SEWAGE DISPOSAL SYSTEM

SUBDIVISION Woodford's Grant III LOT 9 ROAD 11175 Willow Green Way

PLOT PLAN
LOT 9
WOODFORDS GRANT III

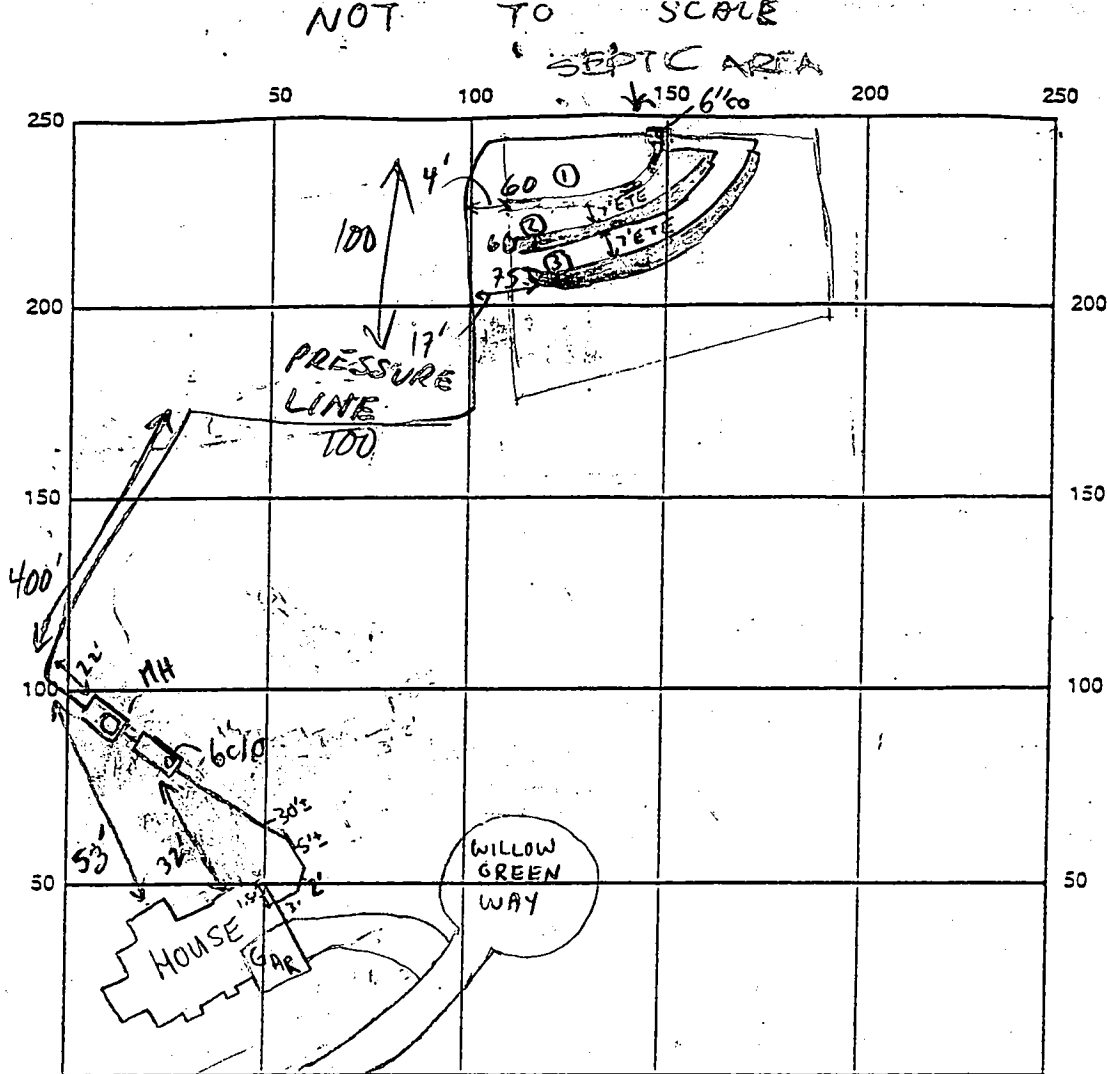
REMARKS: 11/19/99 Due to irreg. topo install DB in center of SDA as shown above
and run trenches on contour initially to the right, then in both directions A
3/6/00 NO TANKS SET. D/S 3/7/00-MET CONTRACTOR AT SITE FOR REVISED

LAYOUT INSP., BECAUSE OF CONTOUR ISSUES, BEST SYSTEM LAYOUT IS TO INSTALL DBOX IN CTR(±) OF
UPPER EDGE OF SDA AND RUN 3x 60' TRENCHES TOWARDS THE 112.1 LOT LINE, UPPER LEFT CORNER OF
SDA IS COMPROMISED BUT CONTOUR LIMITS ITS USE -SRW 3/9/00-1ST TRENCH INSTALLED ON CONTOUR
INSTALL OTHER TRENCHES 7' ETC MINIMUM TO SAVE AREA -SRW 3/13/00 OK TO COVER ALL
TRENCHES, LEAVE OPEN COUPLINGS, LAST TWO BENDS @ PUMP PIT (NR)
 DATE SYSTEM APPROVED 4/24/00 INSPECTOR Steven R. Krieg

3/7/00 Revised DBX LOCATION per SRM
